MAXINE HALL HEALTH CENTER RENOVATION AND SEISMIC UPGRADE

CIVIC DESIGN REVIEW - PHASE 3 : JUNE 25, 2018

MAXINE HALL HEALTH CENTER
RENOVATION AND SEISMIC UPGRADE
REVISIONS AFTER CDR 2 (11/27/2017) APPROVAL

EAST ELEVATION - WALL SECTION (NEWLY PROPOSED)
Scale: 3/16" = 1'

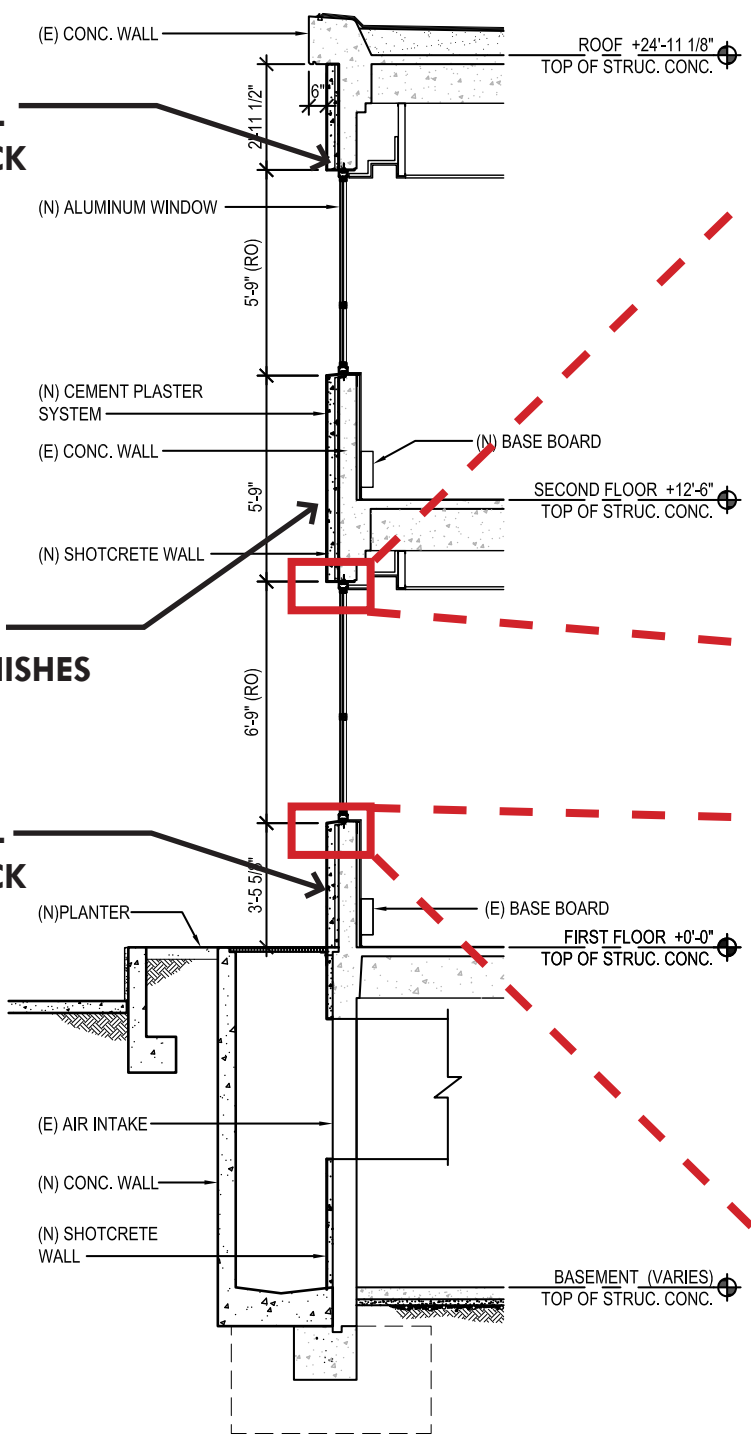
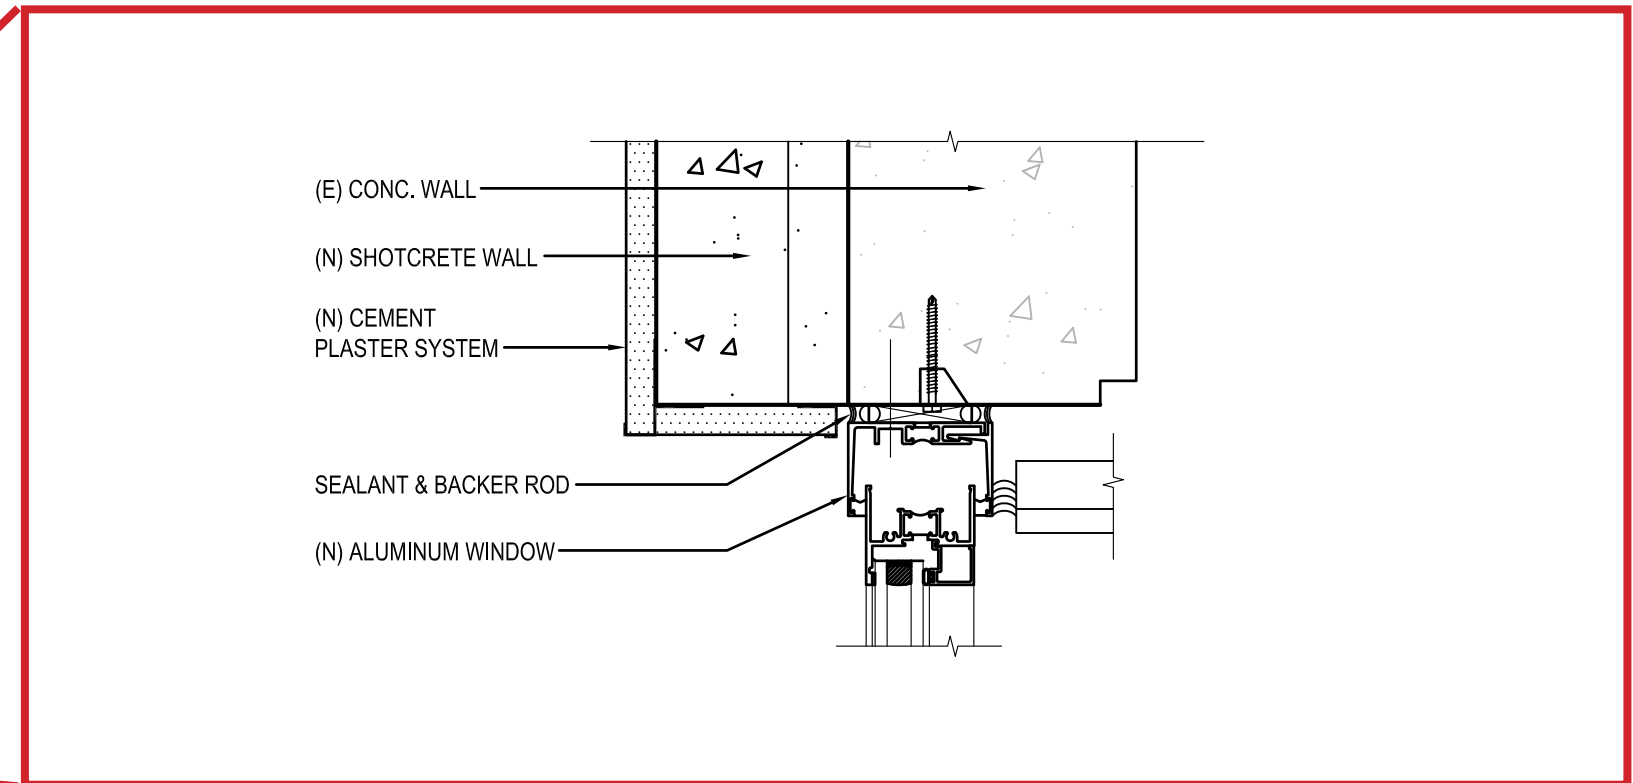
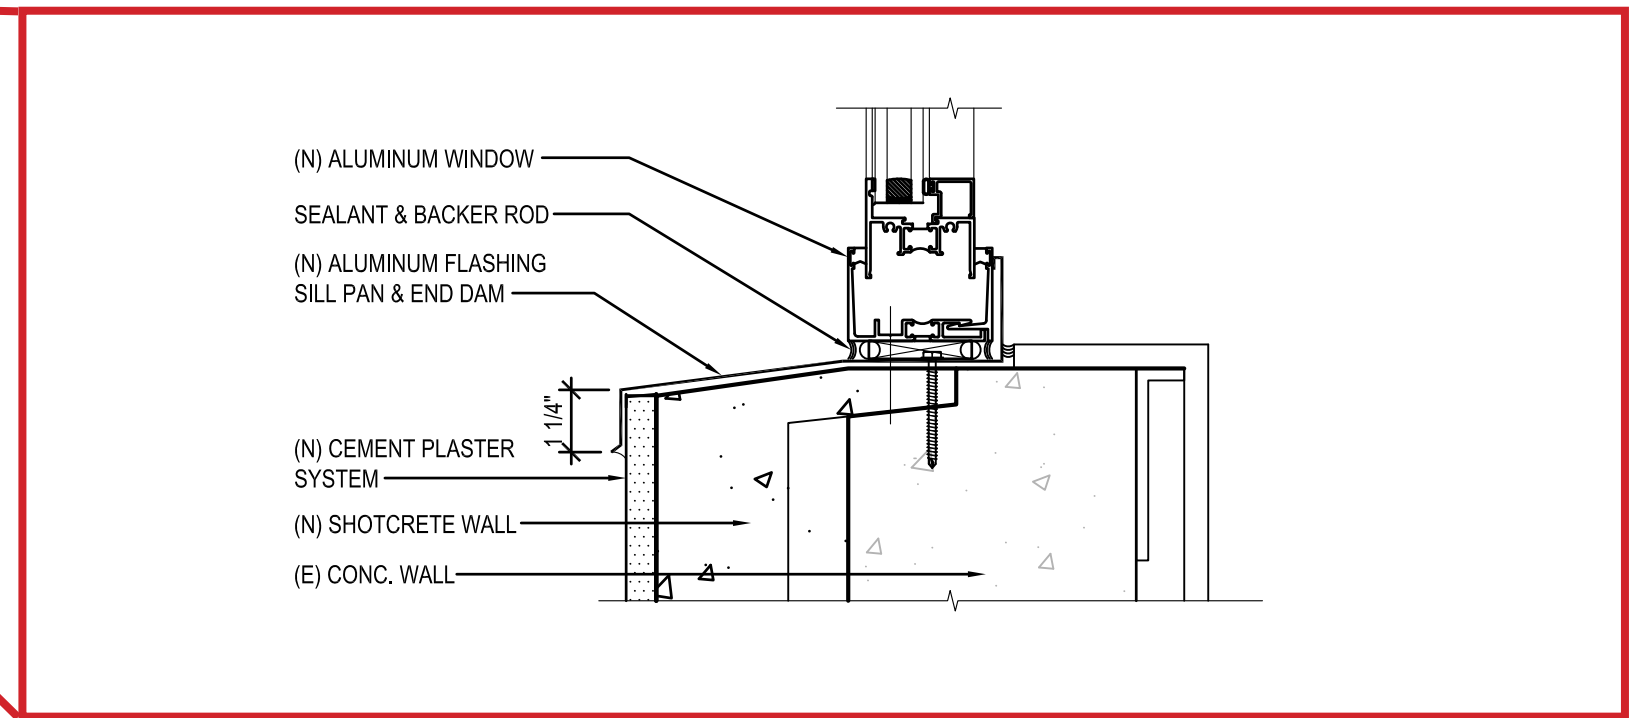
2. East Elevation : East elevation changed back to the proposed CDR 1 (6/19/2017) design:

Historic Preservation Planning recommended that the proposed new window design be consistent with the existing historic character; with clear anodized aluminum frames and similar proportions. The concrete shear wall at the east facade was pushed back to distinguish the existing frame which is considered a character-defining feature. (Revision per Historic Preservation Planning recommendation)

**SHEAR WALL
PUSHED BACK**

**REVISED TO
STUCCO FINISHES**

**SHEAR WALL
PUSHED BACK**

EAST ELEVATION AND ENTRANCE (NEWLY PROPOSED)

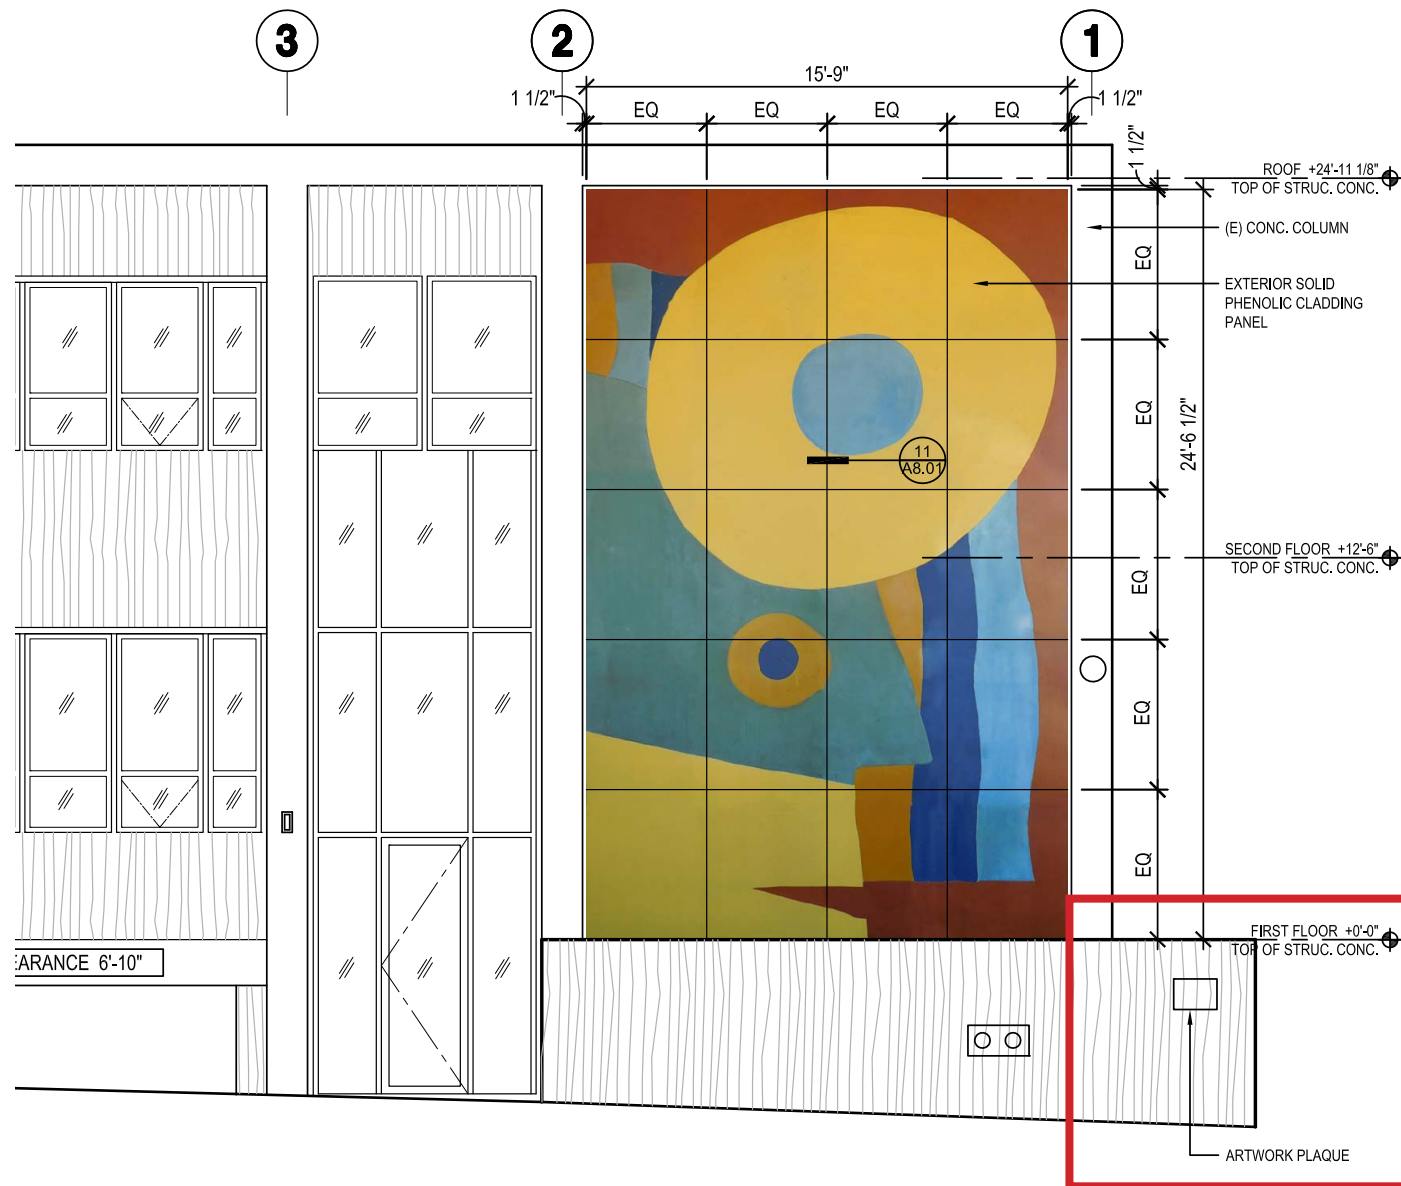
WINDOW SHAPE & SIZE TO BE
CONSISTENT WITH EXISTING WINDOWS

SHEAR WALL PUSHED BACK

SPANDREL REVISED
TO STUCCO FINISHES

RAILING REVISED
(MAYOR'S OFFICE ON DISABILITY
PROJECT WORK SCOPE)

Art Wall Plaque

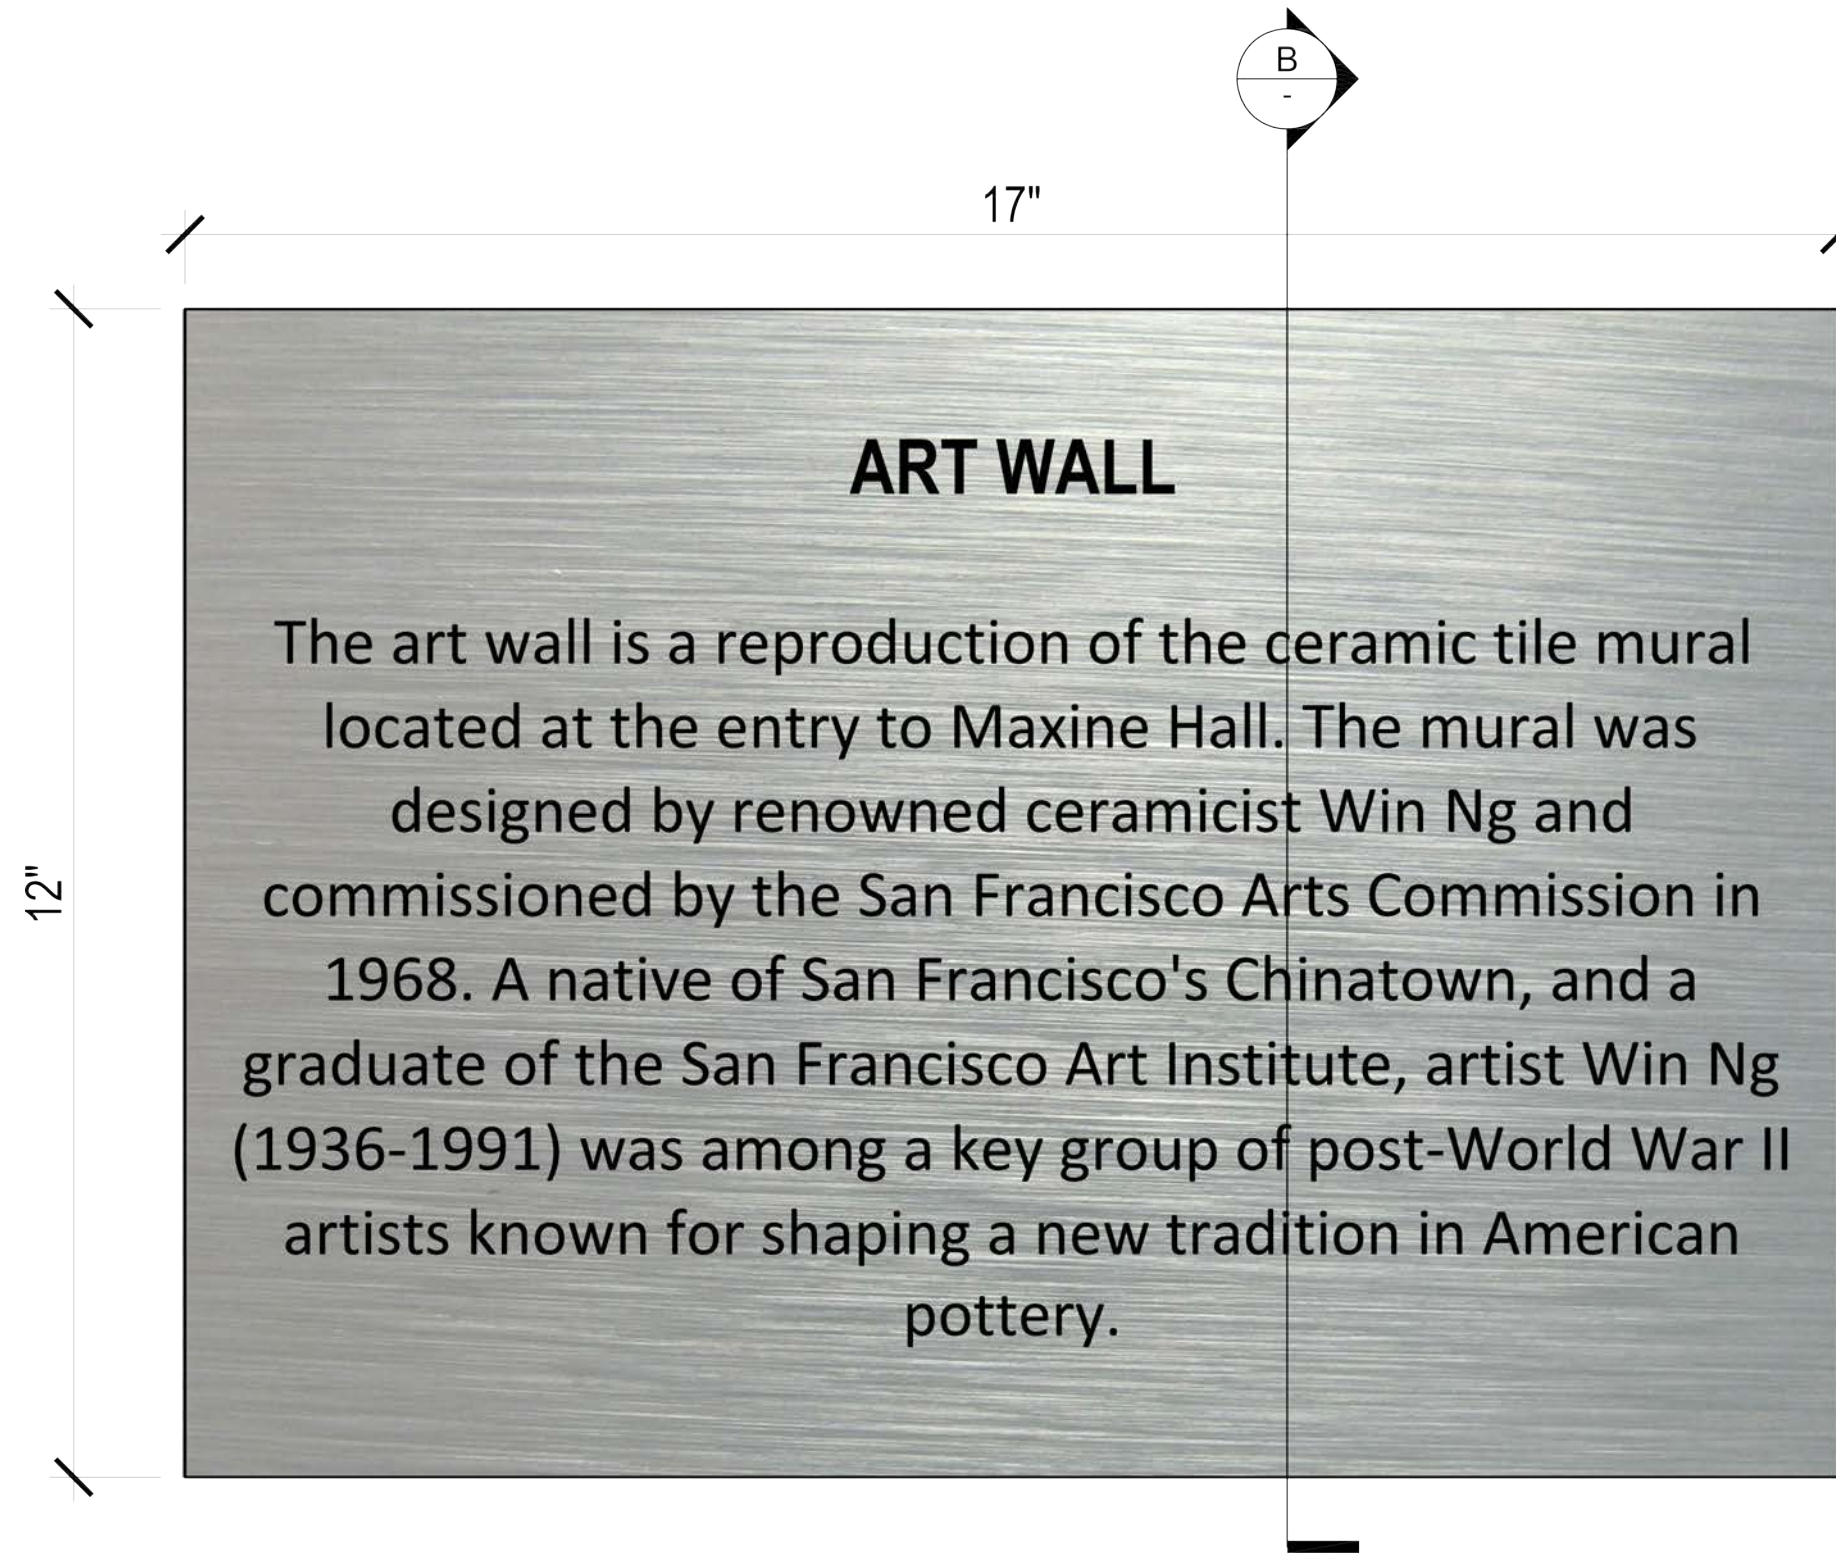
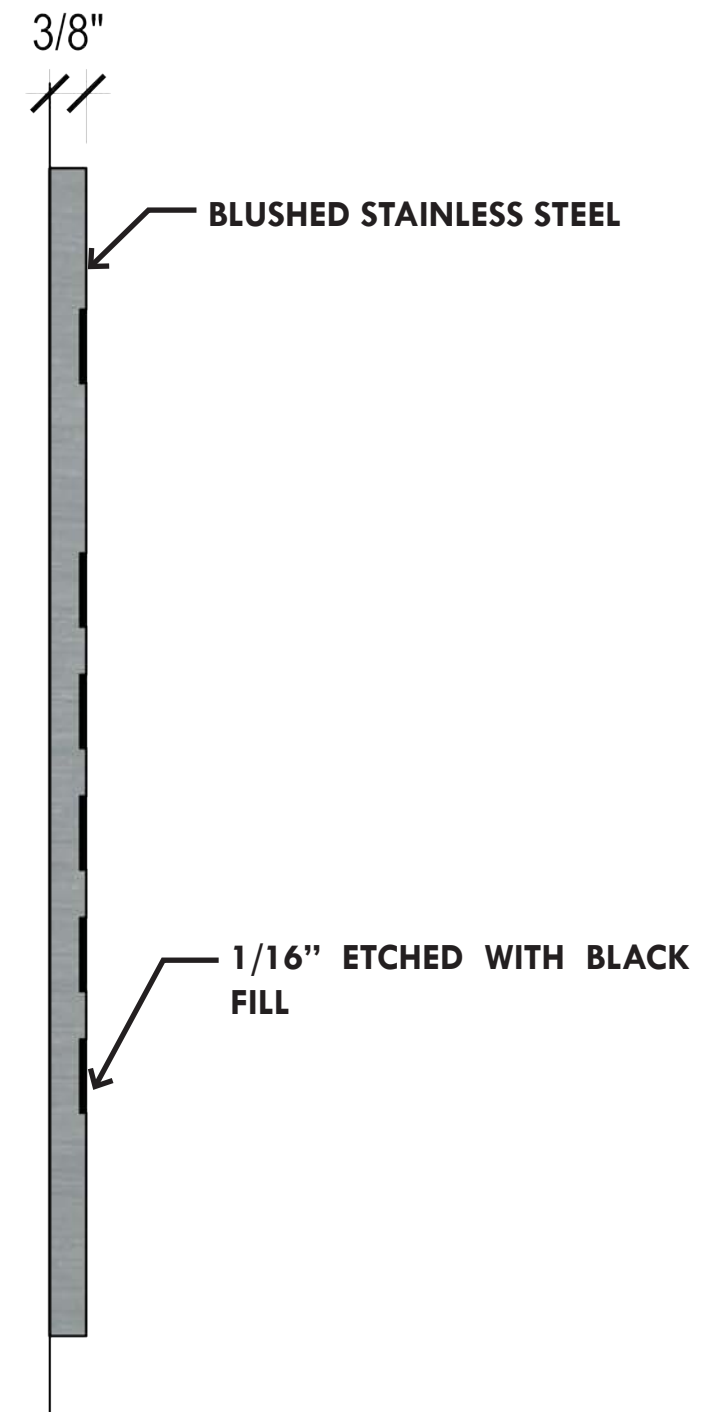
5. Plaque for Art Wall :

We are proposing the Plaque describing the artwork and reproduction be located at south-east corner of building. (Revision made per CDR 2 comment)

PLANTING PLANS (NEWLY PROPOSED)

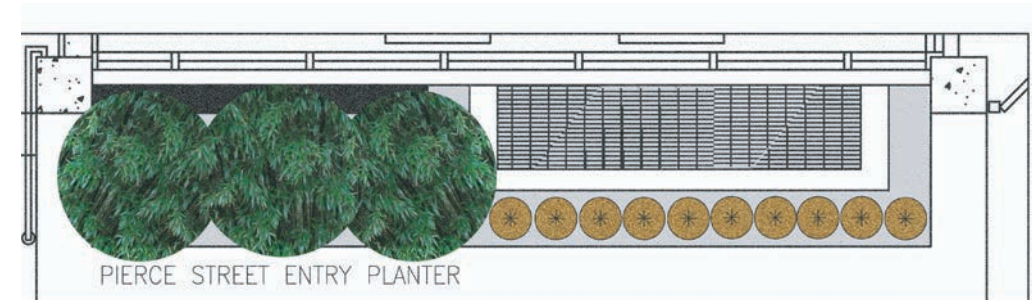
6. Landscape : We are proposing a revised planting scheme (Revision made per CDR 2 comment)
